CITY OF HOUSTON

Subject: Letter of Clarification No. 2 to Invitation to Bid No. S50-C23778 for Replacement of a Pneumatic Ejector System for the Public Works and Engineering Department

**S-50-C23765 – LETTER OF CLARIFICATION NO. 2
REPLACEMENT OF A PNEUMATIC EJECTOR SYSTEM
FOR THE PUBLIC WORKS AND ENGINEERING DEPARTMENT**

9.0 Mechanical Drawing:

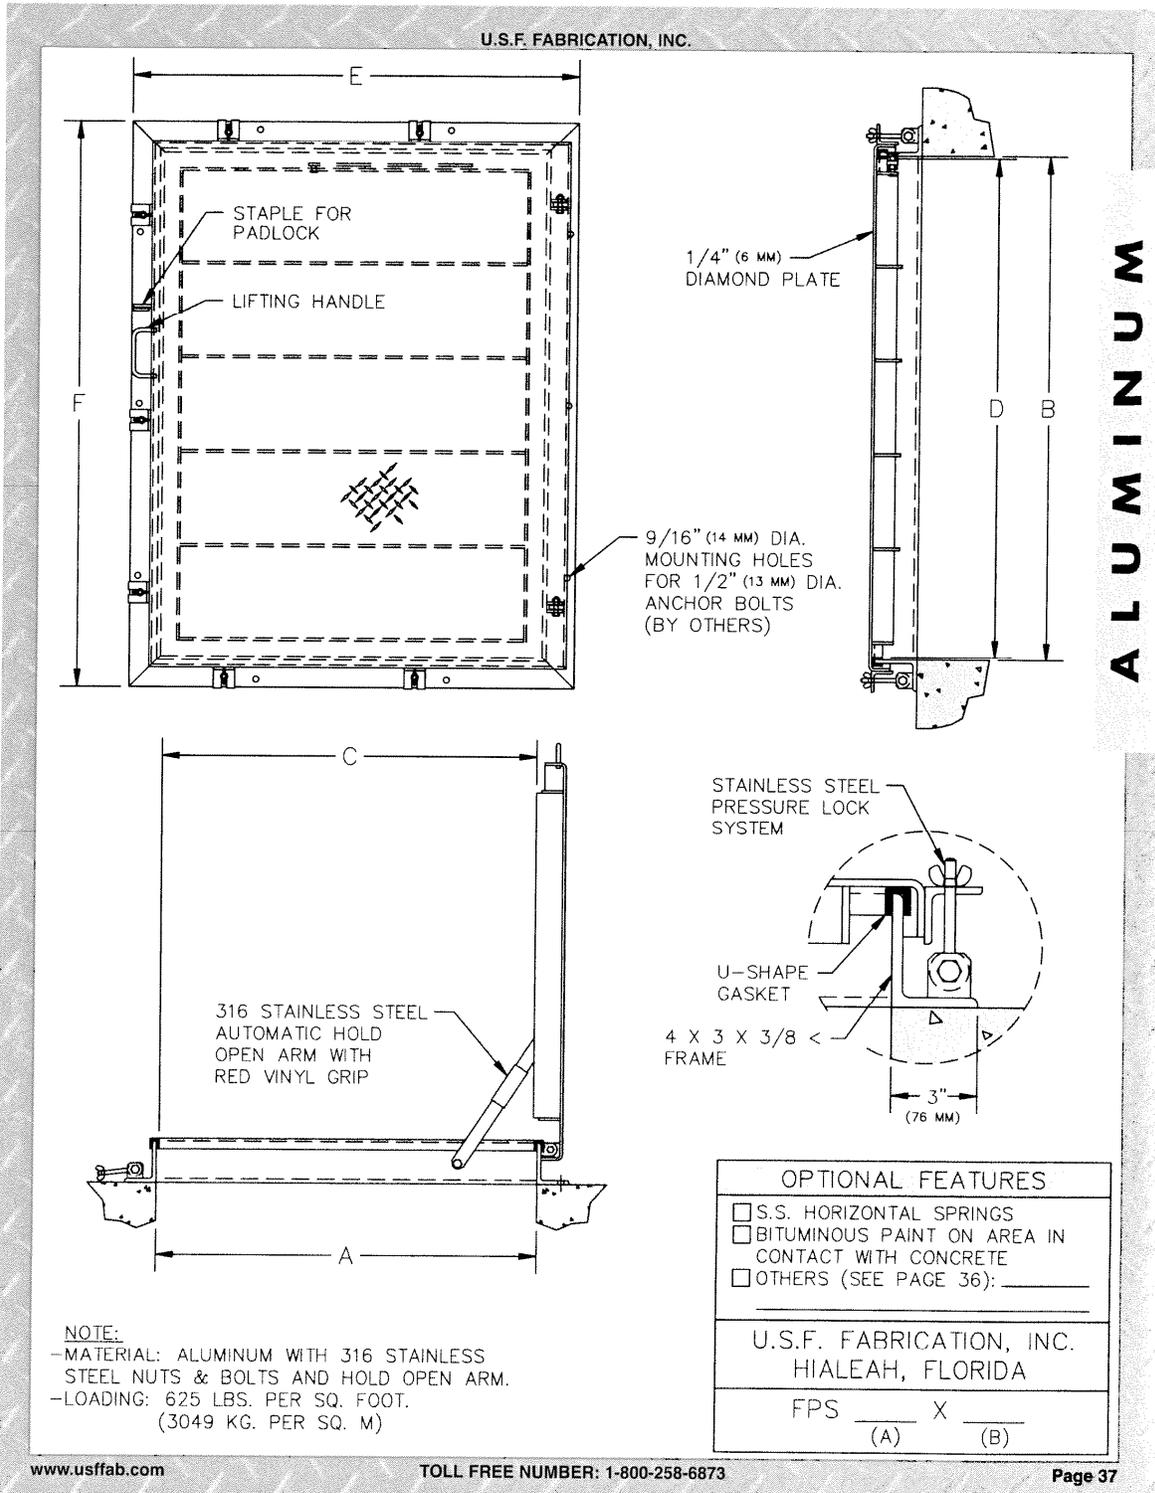
9.1 The mechanical drawings of the Series 4000, Expelsor Pneumatic Ejector System can be viewed beginning on page 9 of 21.

A PDF version of the Mechanical Drawing can be viewed on the following web link
<https://purchasing.houstontx.gov/buyer/BidDocumentManager.aspx?id=C23778>
